TO: West Tisbury Conservation Commission
CC: George A. Sourati, P.E. (Sourati Engineering Group LLC)
FROM: Greg Berman, Coastal Processes Specialist (WHSG & CCCE)
RE: Site report for 271 John Cottle Road, West Tisbury, MA

Site Details: This report focuses on the property of 271 John Cottle Road, in West Tisbury (Figure 1). A NOI has been submitted to the West Tisbury Conservation Commission to rebuild the existing rock revetment, extending it on both ends, and adding a transition of gabions/fiber rolls at the terminus of the structure.

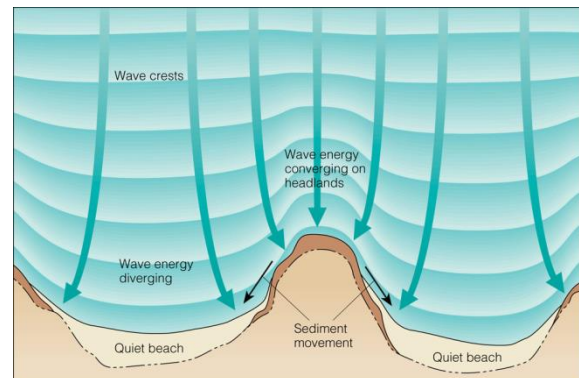
A series of photographs was taken during a site visit on 07/06/2023. Photograph 1 shows the edge of the cottage (built in the 1930s and so pre-dating the Wetlands Protection Act) is ~ 16' from the top of the bank. There has been some minor erosion recently at the top of the bank. There was no observed surface runoff issue at the site despite lawn extending to the top of the bank. A narrow (ex. 5-10') buffer zone of low native vegetation suitable for stabilization might reduce the erosion rate at the top of the bank. This would have little effect on the toe of the bank, which is only stabilized by the remains of a rock revetment. Photograph 2 shows the eastern end of the existing revetment, which extends further seaward than the adjacent shoreline. A cobble deposit extends 5-10' from the toe of the coastal bank. This cobble is more erosion resistant than sand and may be reducing the erosion rate at adjacent areas. The western end of the existing revetment (Photograph 3) also extends further seaward than the adjacent shoreline. There is a similar cobble deposit extending 5-10' from the toe of the coastal bank. The existing boulders from the revetment still provide some protection for the coastal bank, but will become less effective in the future. Areas to the west of the revetment (Photograph 4) have experienced erosion of the toe of the bank, which appears to have led to slumping of portions of the landform down the face of the bank. The cobble berm does not seem sufficient to prevent this erosion.

Above: Graphic showing how the bathymetry near a headland tends to converge wave energy onto the headland. Image from //science.kennesaw.edu

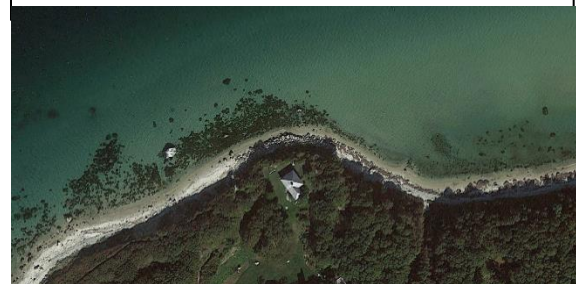
It is likely that wherever this revetment ends it will experience high potential erosion due to “normal” terminal effects of the revetment, combined with the wave energy converging on the headland-type shoreline. An important element of CES design is how the CES transitions to the native coastal bank material. This site is especially susceptible to terminal erosion, and the proposal does include a reasonable transition of gabion baskets and fiber rolls. Both of these should remain covered with beach compatible sediment in order to prevent the materials from breaking down too quickly and to reduce the wave impacts to the adjacent beach. If regulators determine there is a need to maintain the beach in front of the gabion/fiber rolls, then a triggered nourishment requirement (aka trigger) might be included in the Order of Conditions, either instead of, or in addition to the annual requirement. When the beach drops below an elevation-based marker for a designated period of time, nourishment would be brought in to bring the beach back up to design elevation. This type of nourishment strategy would require a monitoring plan. More information on monitoring plans, triggered nourishment, and beach

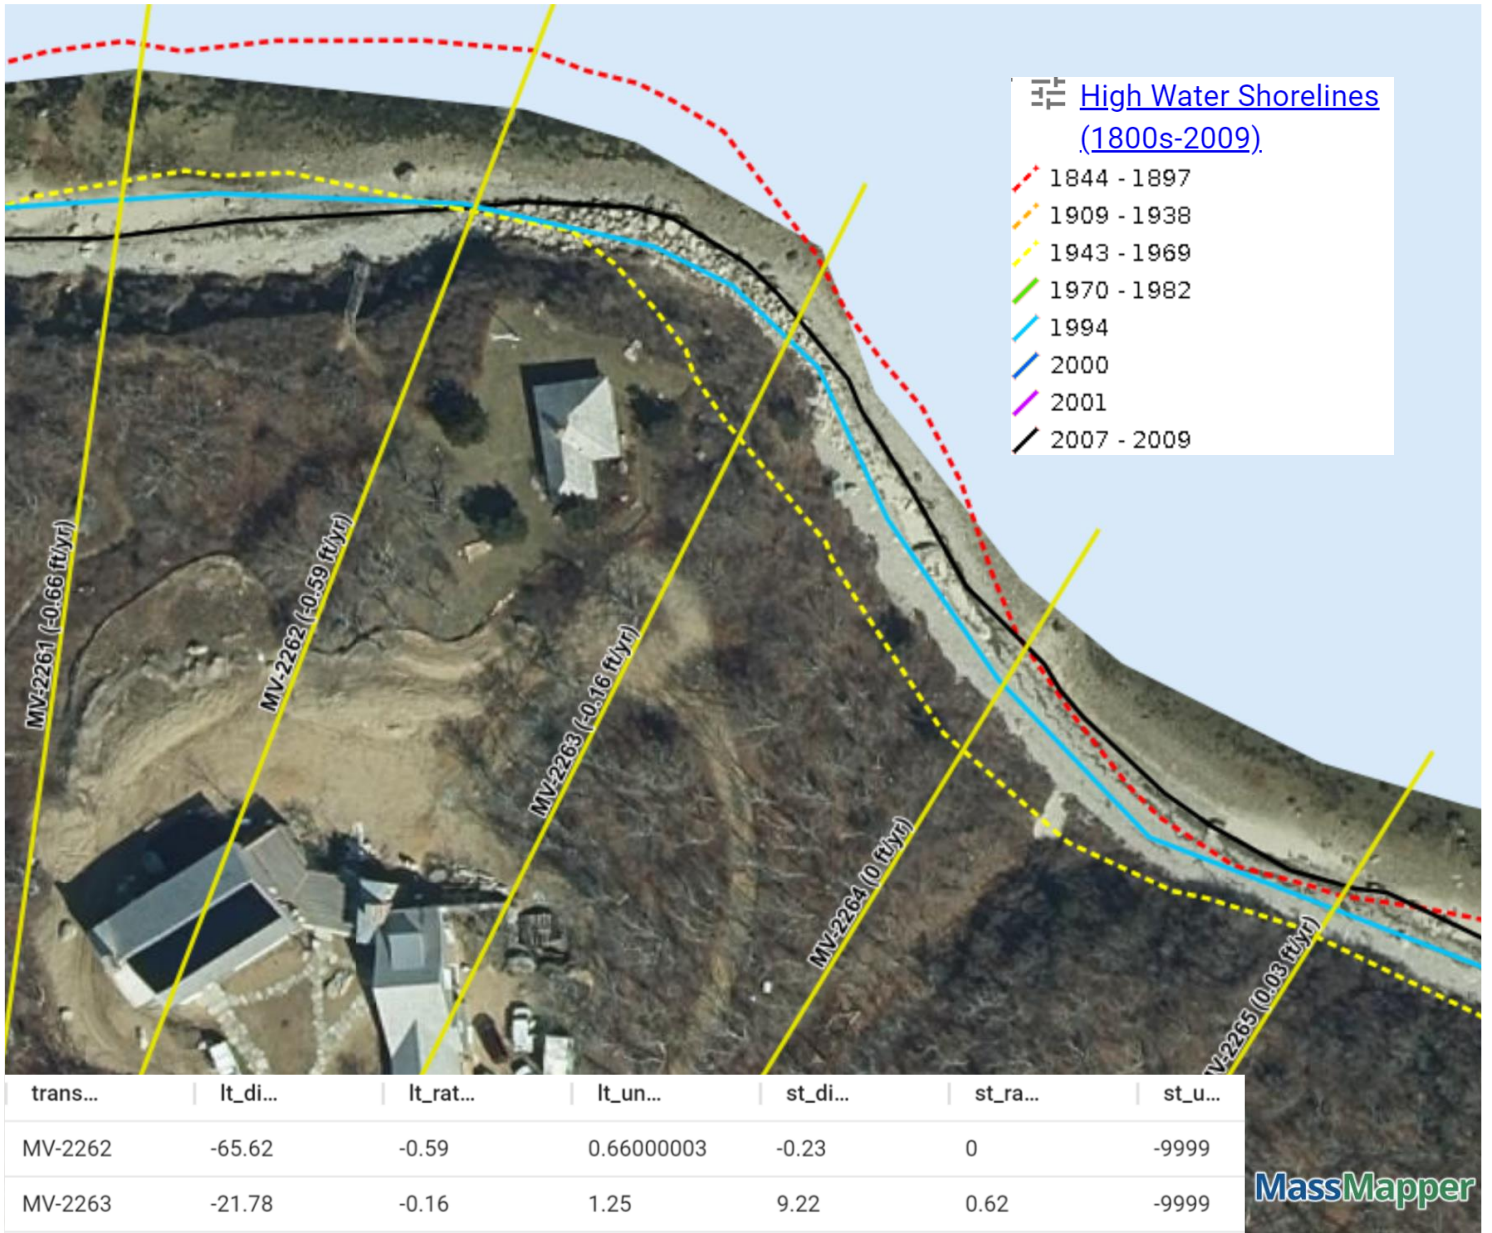
After the site visit, historic shoreline migration trends were examined through a time series of shorelines available from the Massachusetts Shoreline Change Project as shown on the Shoreline Change Viewer of the MassMapper website provided by Massachusetts Office of Coastal Zone Management. (Figure 2 , data available at <https://maps.massgis.digital.mass.gov/MassMapper/MassMapper-CZM-Shorelines.html>). At this location short term rates should not be used due to very high uncertainty (labeled -9999 on the table). The long term rates also have uncertainty values higher than the rates, indicating that the actual long term shoreline change rates could vary from 1.41'/yr of erosion to 1.09'/yr of accretion. The 1943-1969 shoreline is further landward than the current top of bank indicating coastal bank formation since that time, which is highly unlikely. This shoreline change data is not very accurate, but still may be the best available. The +/- 60 cubic yards of proposed annual sand nourishment is likely a sufficient volume to make up for the loss of eroded material supplying downdrift beaches.

Figure 2. Screenshot of data from the Massachusetts Shoreline Change Project as shown on the Shoreline Change Viewer of the MassMapper website provided by Massachusetts Office of Coastal Zone Management. (Data available at <https://maps.massgis.digital.mass.gov/MassMapper/MassMapper-CZM-Shorelines.html>). Short term rates should not be used due to very high uncertainty, and the long term rates also have high uncertainty. The 1943-1969 shoreline is further landward than the current top of bank indicating coastal bank formation since that time, which is highly unlikely.
